SOUTH CAROLINA
DEPARTMENT OF HIGHWAYS AND PUBLIC TRANSPORTATION
P O BOX 191
COLUMBIA, S.C. 29202

BDF
DM0793

MEMORANDUM TO DESIGN GROUP LEADERS & CONSULTANTS

SUBJECT: Concrete Barrier Parapet Reinforcement

BARRIER PARAPET DETAILS

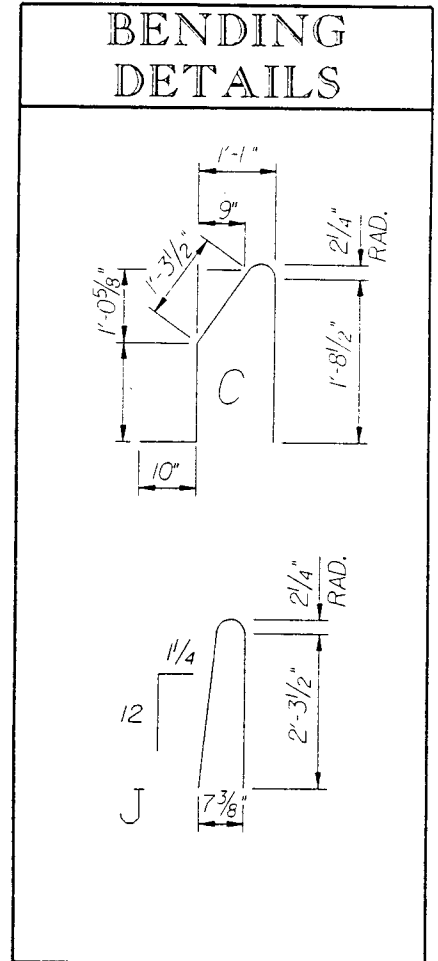
The standard concrete barrier parapet details have been revised as shown on the attached detail. The revisions are a result of problems with insufficient concrete cover after reinforcement placement.

The detailer should pay special attention to barrier reinforcing steel placement for structures with superelevated sections as this magnifies the problems.

Note: A 1/2" extension of the concrete slab beyond the outside face of the barrier parapet will be required if the contractor elects to slip form the barrier parapets. No additional reinforcing steel is required and the payment for class "D" concrete in slab will be for quantity shown on the plans.

* The 3/4" groove at construction joint
may be omitted when slip form is used.
